Subject: Safety Recall 00V-338.001 NSA-11paw
(Ford Number 00S36)

SUBJECT: DEMONSTRATION / DELIVERY HOLD: Safety Recall 00S36: Certain 2001 Model Year Mercury Villager – Front Seat Belt Buckle Assembly Inspection

VILLAGER SEAT BELT BUCKLE INSPECTION AND REPLACEMENT

FIGURE 1

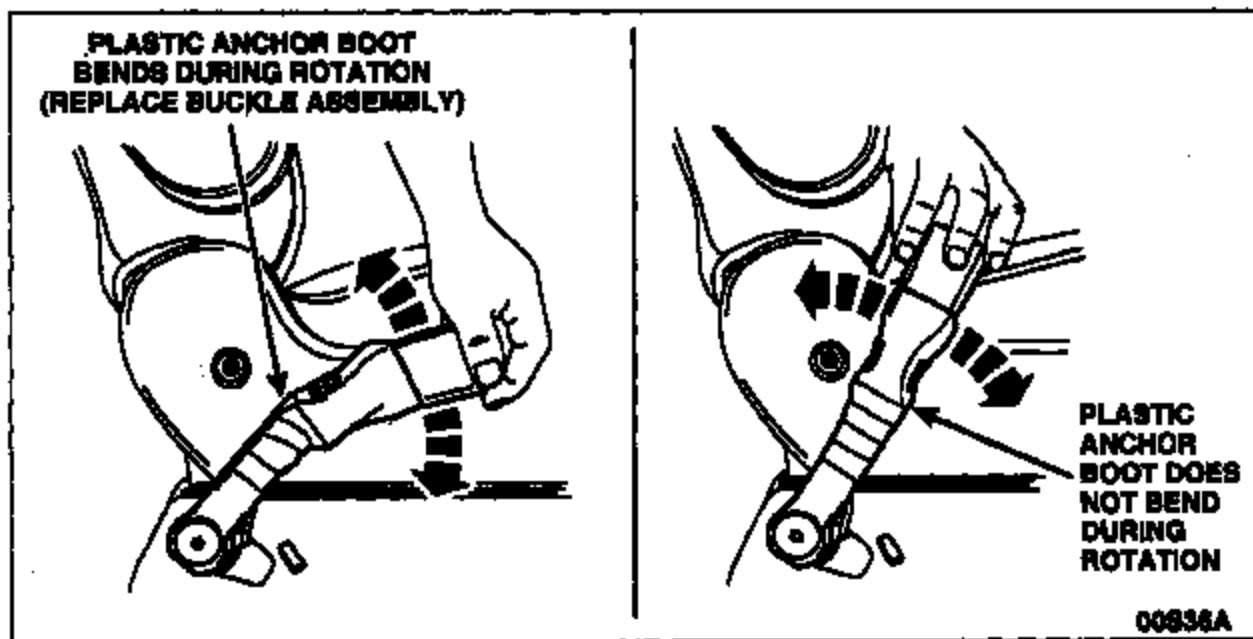
1. Grasp the end of the seat belt buckle and rotate the buckle assembly forward and backward as shown in the illustration. The buckle assembly should rotate freely and the plastic anchor boot should remain straight. See Figure 1.
 - If the effort necessary to rotate the buckle assembly bends the plastic anchor boot, replace the buckle assembly. Any bending of the plastic anchor boot is **NOT** acceptable. Refer to the service procedures in Section 501-20A of the appropriate Workshop Manual.
 - If the buckle assembly rotates freely and the plastic anchor boot does not bend, continue with the inspection procedure.
